BOARD OF APPEALS

2025-0002 V-24-37 - 440 Belada Blvd -Request for a variance from Section 9.2.3. to allow a pool and associated structures to encroach into the 75-foot impervious surface setback.
(Presented by LaQuita Williams, Planner II)

Board of Appeals

440 Belada Blvd

Site Plan

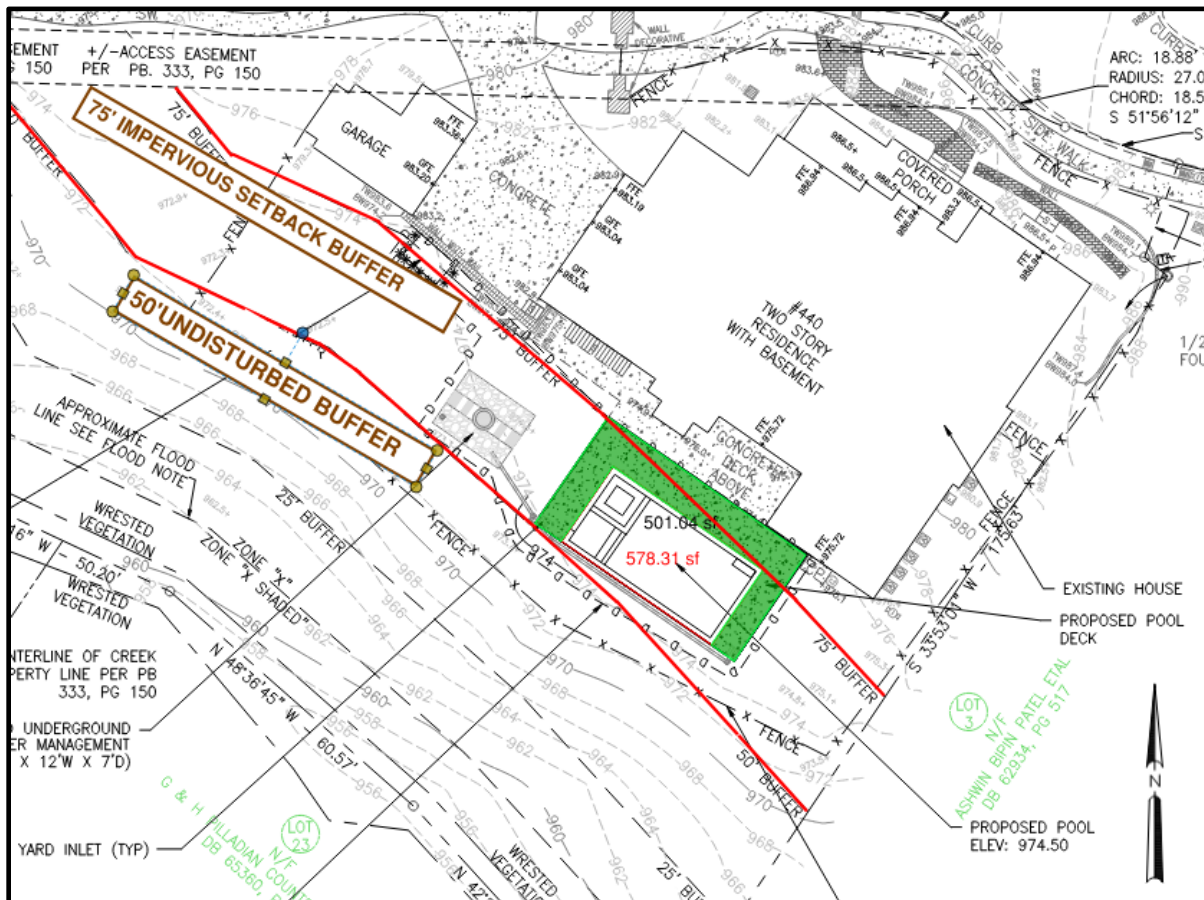
The applicants are seeking a variance to encroach 25 feet into the 75-foot impervious surface setback to place a pool and deck. The proposed pool will be 579 square feet and the proposed deck will be 503 square feet for a total of new impervious surface of 1,082 square feet, of which 975 square feet will be within the 75-foot impervious surface setback.

Per the Development Code section 9.2.3.A.2. *Land Development Requirements*, “All impervious surfaces are prohibited from an additional setback of 25 feet, measured horizontally from the 50-foot vegetative buffer”

Red lines are the stream buffers, lime green represents the proposed deck and pool

C-1

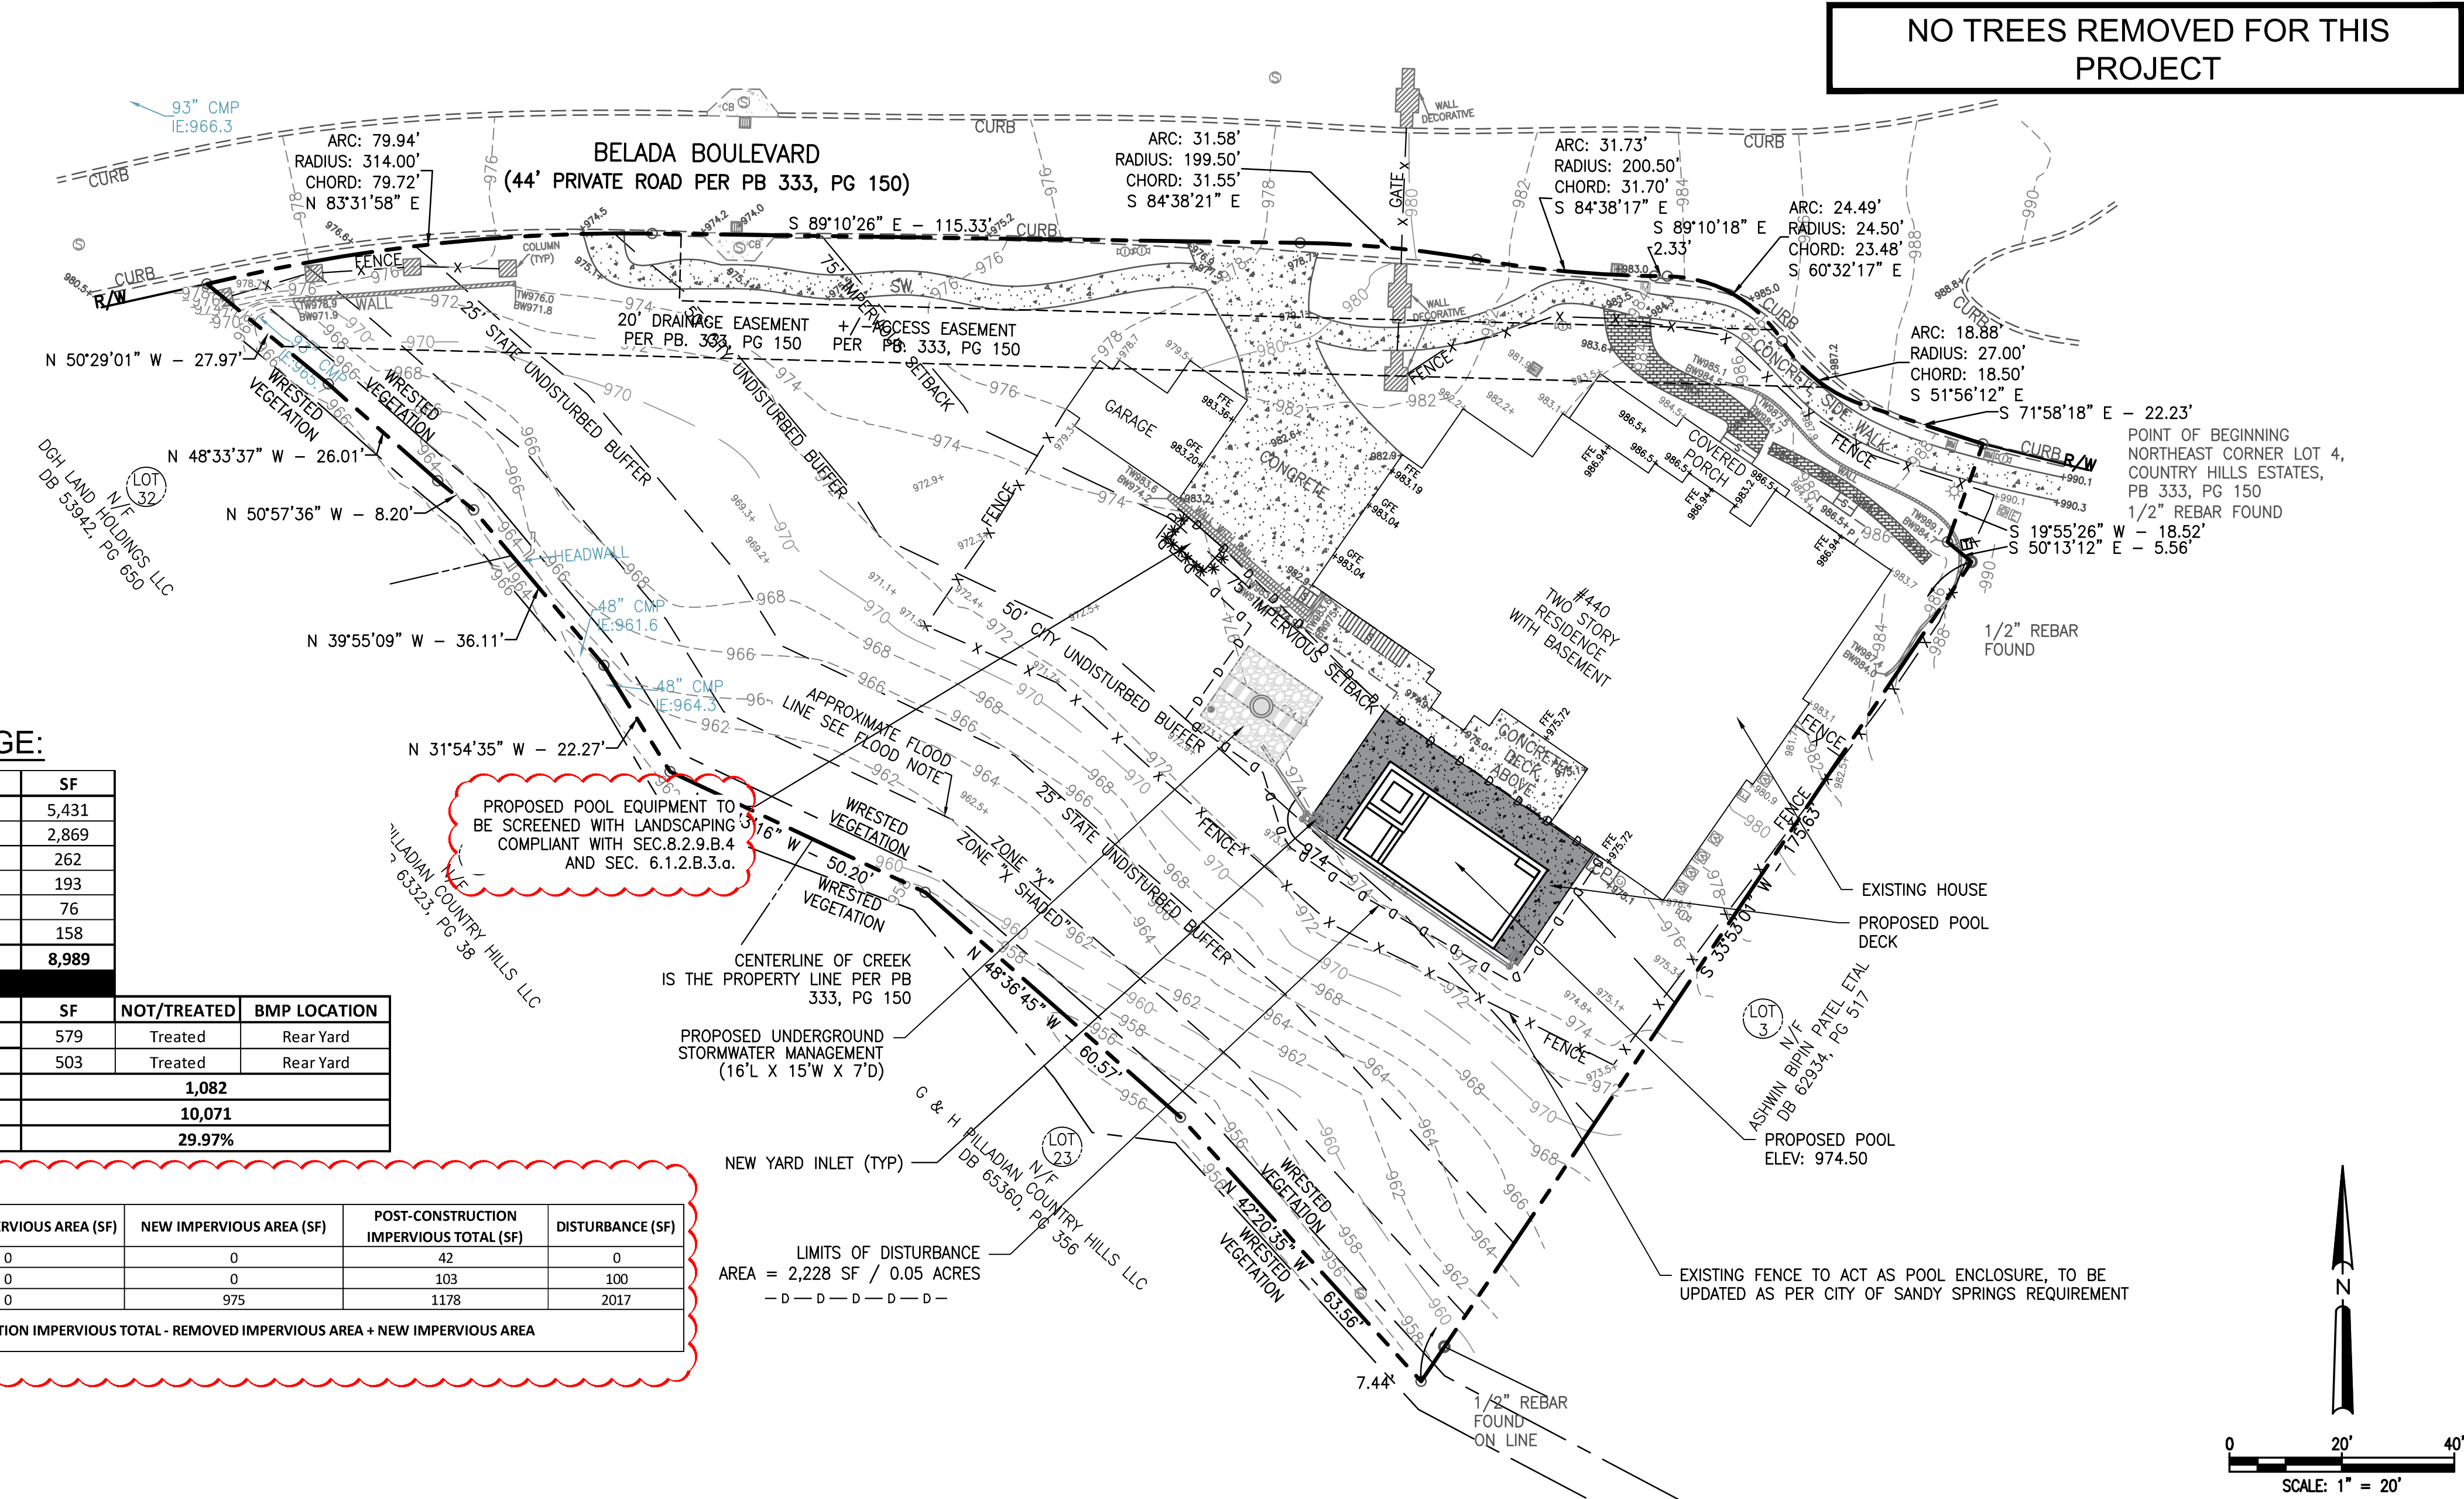
1. A note on Sheet C-1 says, "Existing fence to act as Pool Enclosure, to be updated as per City of Sandy Springs requirement." The City of Sandy Springs is currently enforcing the pool barrier requirements from the 2018 ISPCS. Provide photos with measuring tapes to illustrate the existing fence and state what you plan to do to bring the existing fence into compliance. Alternatively, an automatic pool cover could be installed.

4. Provide this note: Provide pool alarms on all windows with a sill height of 48 inches or less above finish floor that open onto the pool enclosure, as well as all doors that open onto the pool enclosure. Note that alarms must comply with UL2017. (Typical home security alarms do not meet the requirements.)

5. Please add a large, prominent note to the plans specifying that Sandy Springs requires a BUILDING Pre-Construction Meeting for all swimming pools -- with a Building Inspector -- which should be requested through the online portal. This is in addition to the SITE Pre-construction meeting. Contractors who skip their Building Pre-construction meeting (or other required inspections) will be fined for doing so. See IRC Sections R109.3 and R109.4.

- That all new impervious surfaces and site disturbances be confined within the 75-foot impervious surface setback,
- The deck shall be installed with artificial turf in lieu of the pool deck, installed according to the City's detail,
- Stormwater Management Plan be approved by the City Engineer, and
- Construction be substantially similar to the proposed site plan.
